RE: 579.5 Notices, bulletins, customer satisfaction campaigns, consumer advisories, and other communications for the month of November, 2015.

Bulletin Number: I-15-04
Model Year(s): 2015-2016

SUBJECT: 2015-2016 Indian Full Size Motorcycles – Rear Master Cylinder Repair

SUBJECT: SLINGSHOT – REAR SPROCKET RETAINING NUT RUNNING CHANGE

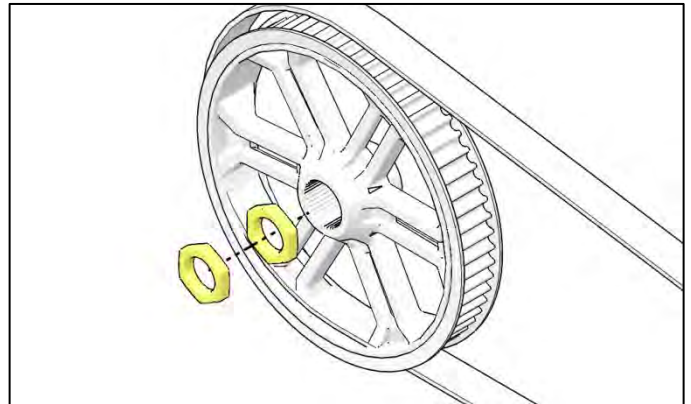
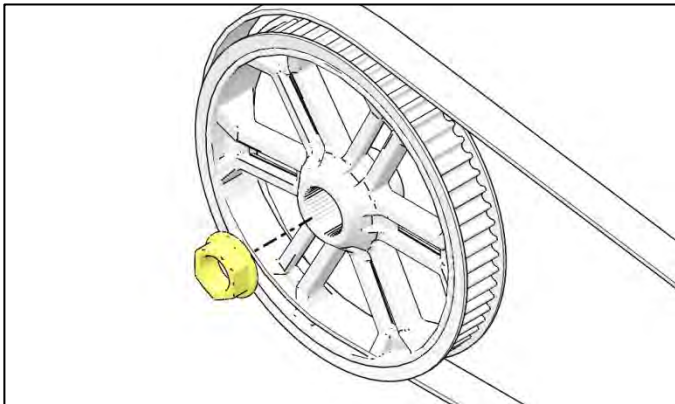
The Slingshot Division of Polaris Industries has developed updated rear sprocket retaining nuts and Loctite® on 2016 Slingshot models manufactured after 11/02/2015. The single hex flanged-style nut has been replaced with two hex head nuts. Loctite® 641 (Yellow) applied to the rear axle splines and threads has been replaced by Loctite® 680 (Green).

Updated rear sprocket retaining nuts and Loctite® should be installed on any vehicles built prior to 11/2/2015 if any of the following conditions are encountered:

1. A clicking or popping noise from the rear axle area during low speed operation
NOTE: This noise is similar to and may be mistaken for a damaged rear wheel bearing
2. Reduced clamp force on the rear sprocket nut
3. A service procedure requiring removal of the rear sprocket is performed

OLD (PN 7547617 – QTY 1)

NEW (PN 7547831 – QTY 2)

250 lb-ft (339 Nm)

Inside Nut: **250 lb-ft (339 Nm)**
Outside Nut: **150 lb-ft (203 Nm)**

Loctite® 641 (Yellow)

Loctite® 680 (Green)
